Re: Snow Vista Self Storage 9850 De Vargas Rd SW Conceptual Traffic Circulation Layout Engineer's Stamp 09-26-23 (M09D012B)

The conceptual TCL submittal received 09-27-23 is approved for DHO and/or DFT submittal. When submitting this project through the building permit process, a full Traffic Circulation Layout will need to be submitted and approved prior to building permit.

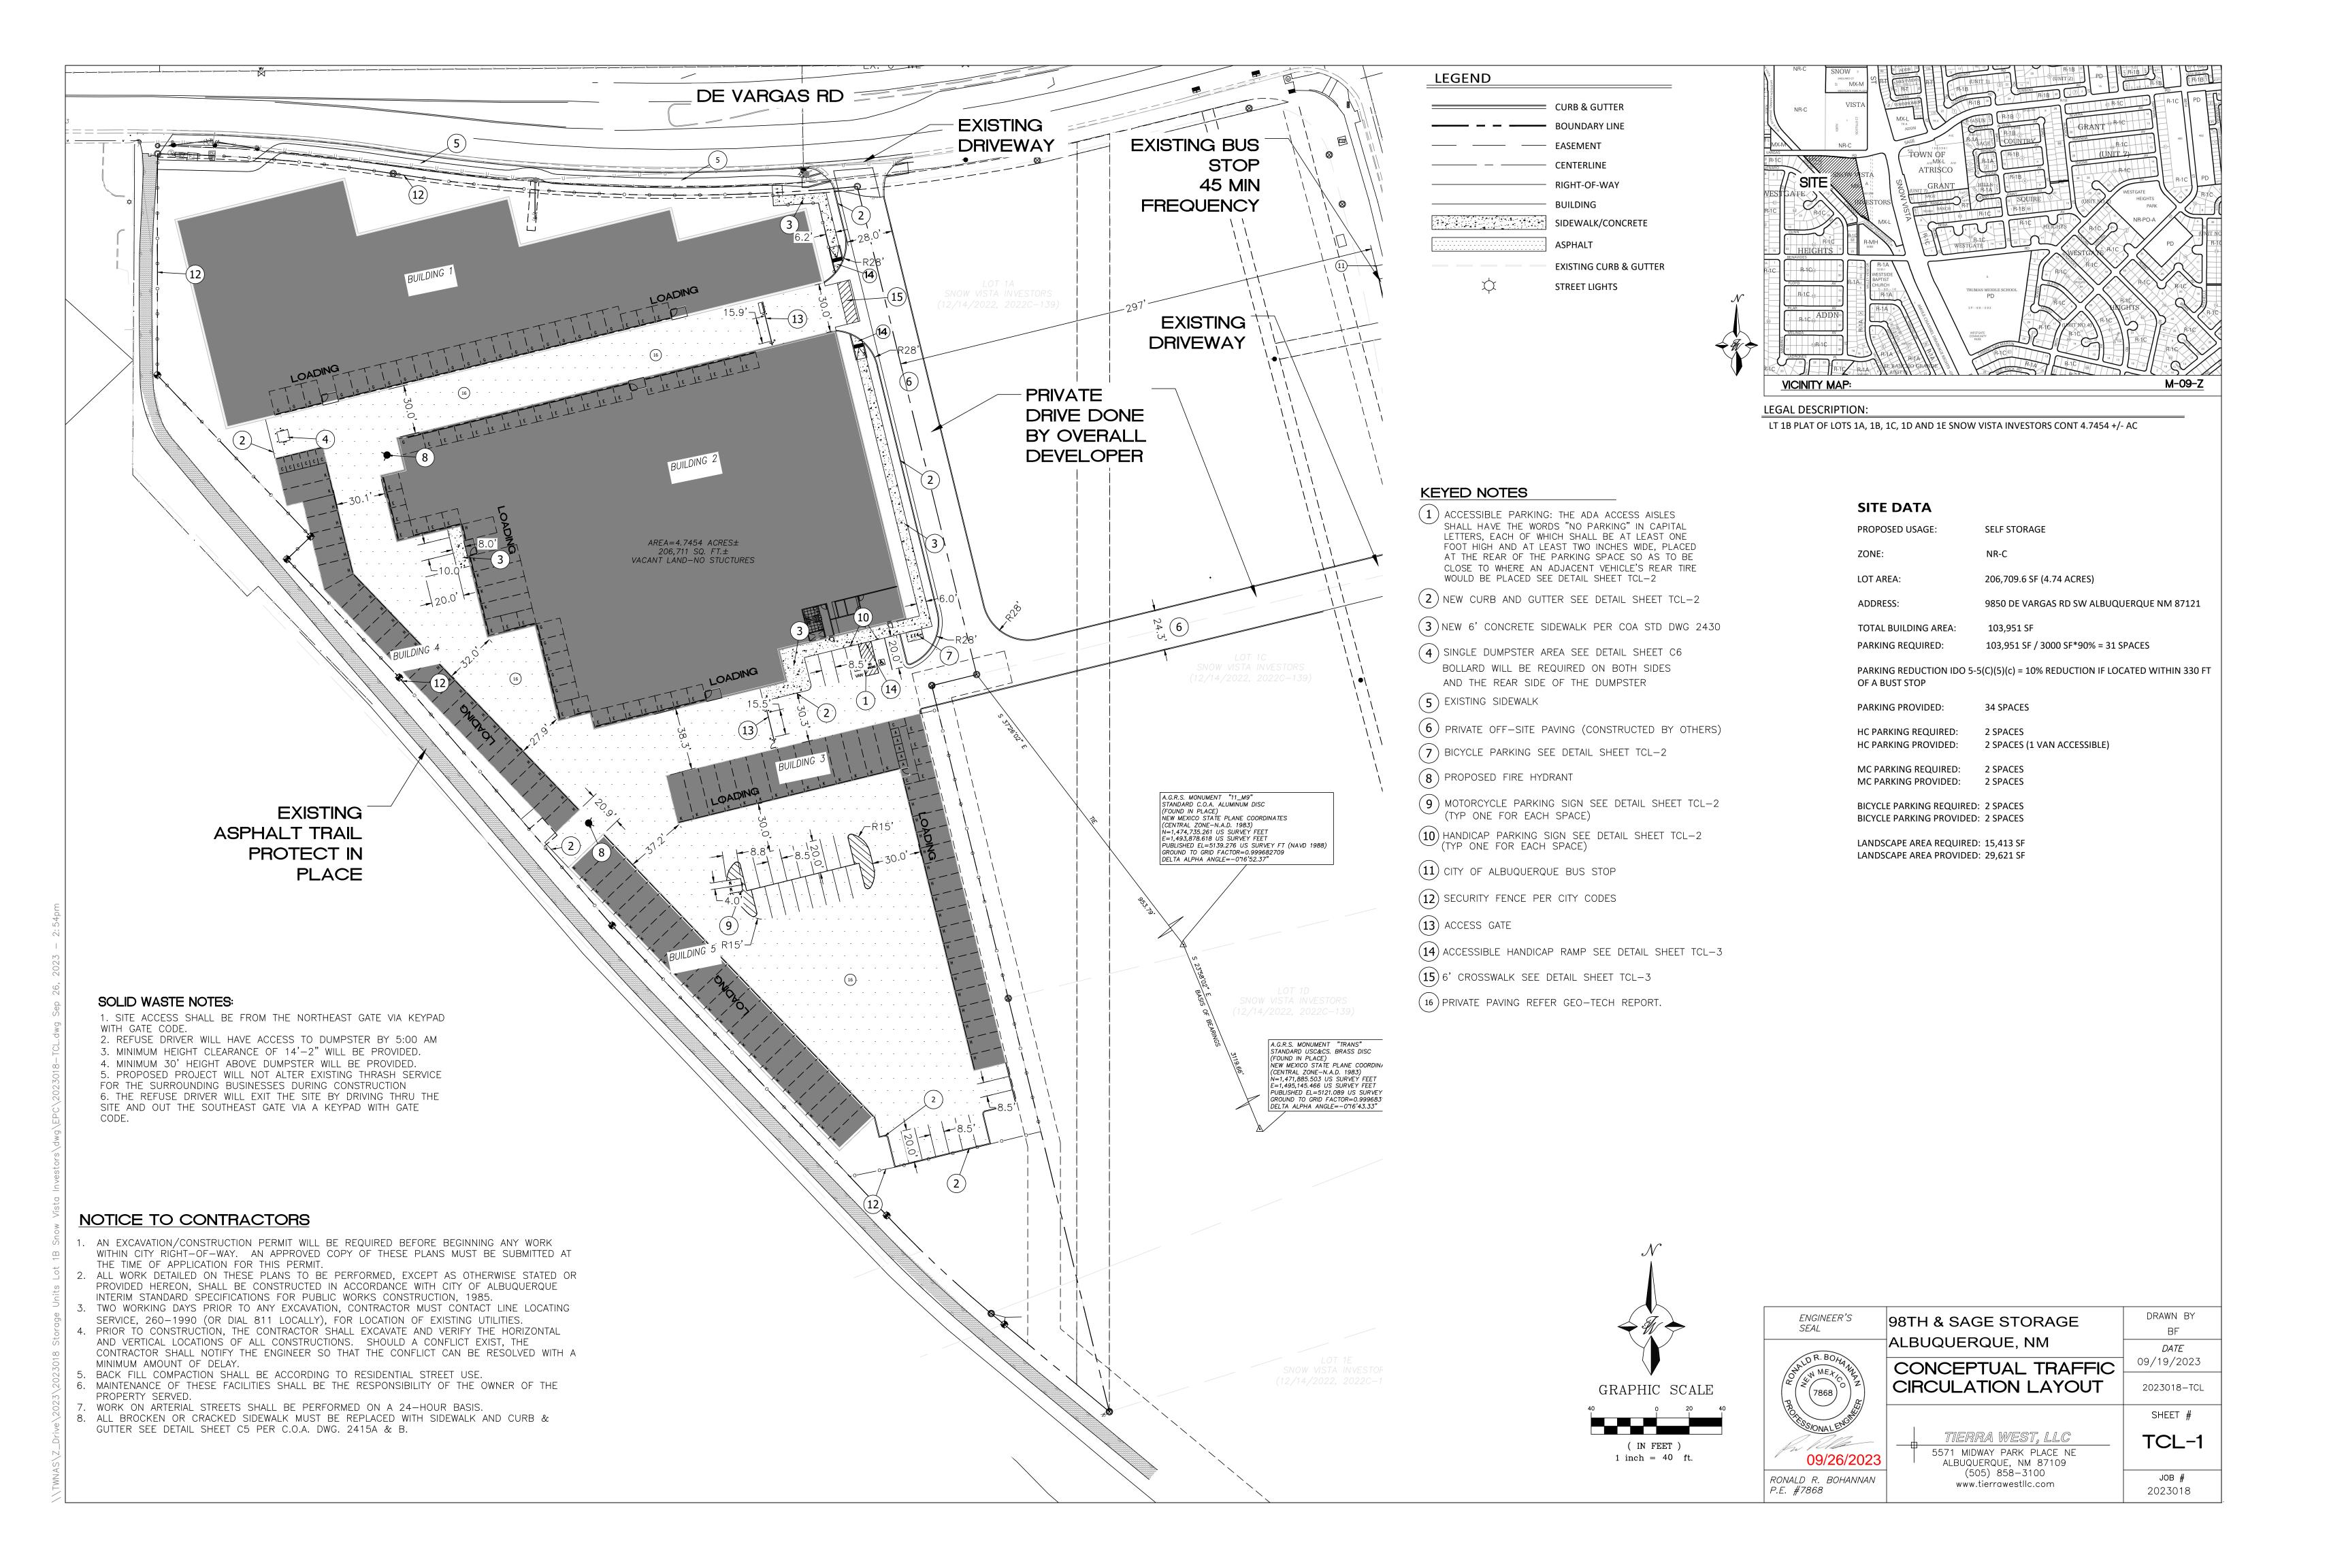
1. It is not uncommon for projects with 5 buildings for the buildings to be built at different times (phased). If this project is to be phased, please indicate this and include the associated parking with each phase.

2. The TCL uses building numbers, while the Fire One Plan and the Solid Waste plan use letters. They should both use numbers or both use letters to facilitate the building permit/CO process.

- 3. The TCL shows the access width through the gate of 15.9 feet (N) and 15.5 feet (S) and the Solid Waste plan shows the access width to be 15 feet 2 inches. The Fire One Plan appears to show an access width of 26 feet.

- All plans should have the same dimension. If the Fire One Plan is revised to clarify this dimension, then provide the approved revised Fire One Plan.

- 4. Please clarify the office location.
- 5. It does not seem pertinent to specify "Private Drive done by Overall Developer" as the drive is needed to support the buildings.

- 6. Show the access easements and provide the plat or shared access agreement.
- 7. The parking/curb line at the south end on the site plan is different than the fire one plan, solid waste plan and grading plan. How is it to be configured?

- 11. Provide the radius for the "ends" (3 feet) of the parking islands.
- 12. Show the entire private drive out to Snow Vista Blvd.

ACCESSIBLE PARKING SIGN

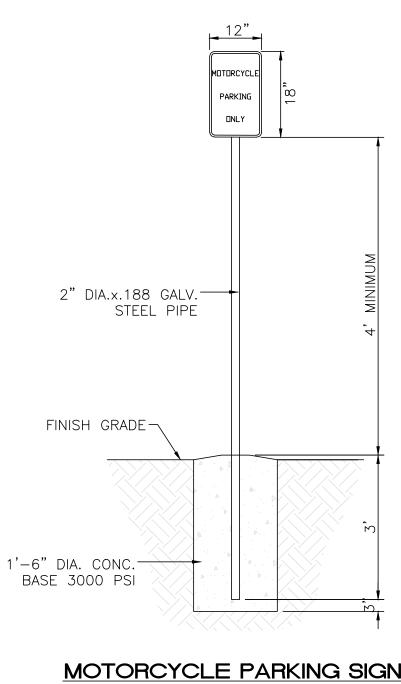
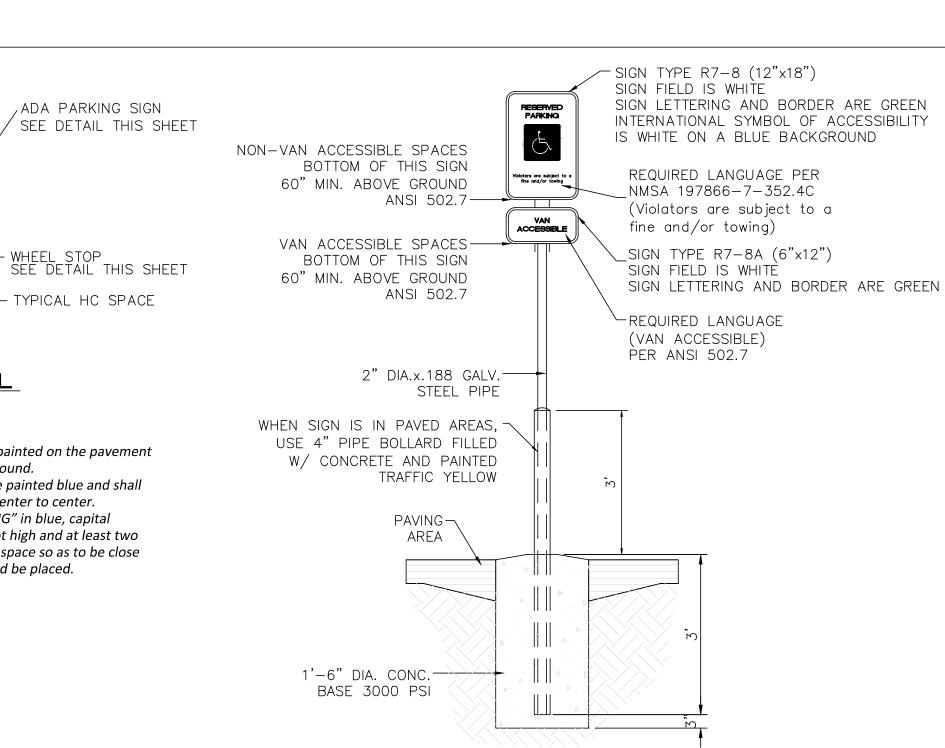
- 8. Provide three bicycle parking spaces.
- 9. Provide a detail for the motorcycle pavement markings.
- 10. Please remove the redundant Accessible Parking Sign detail.
